Dokumenttitel - Document title:			Dokumenttyp - Document: type	
Model Difference letter DH5			Description	
Uppgjord av - Prepared by:	Godkänd av - Approved by:	Datum - Date:	Version:	Dok.nr - Doc no.:
SEPSg		2010-10-14	C

This document is intended to be used for describing the differences between the different variants of the DH5 handset from a certification point of view..

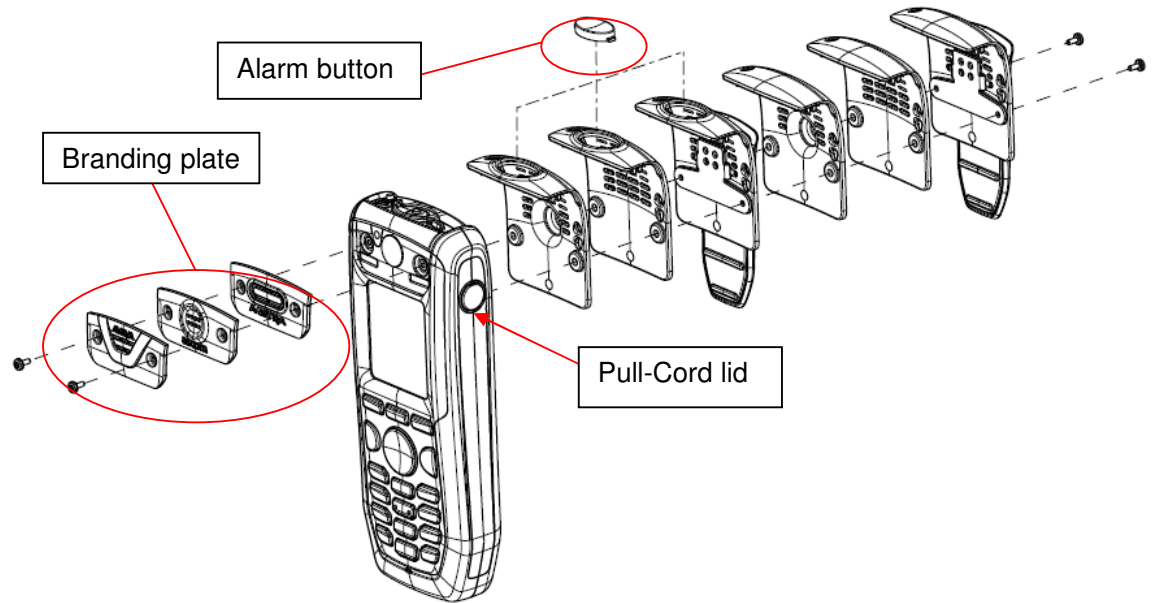
For Bluetooth: DH5-CAABAA is the only current model without Bluetooth, there just the hardware for Bluetooth is not mounted compared to the other models

- The branding plate (plastic marking) and label is different

1. The version without Alarm will not have the electronic parts for the pull cord switch and the NM/MD mounted on the PCB. And the alarm button on top of the handset are removed in the plastics, the electronic switch are still mounted.
2. The versions without NM/MD will not have the components for NM/MD mounted on the PCB.
3. The version without Pull-Cord will have a lid over the mechanical connection of the "pull cord".
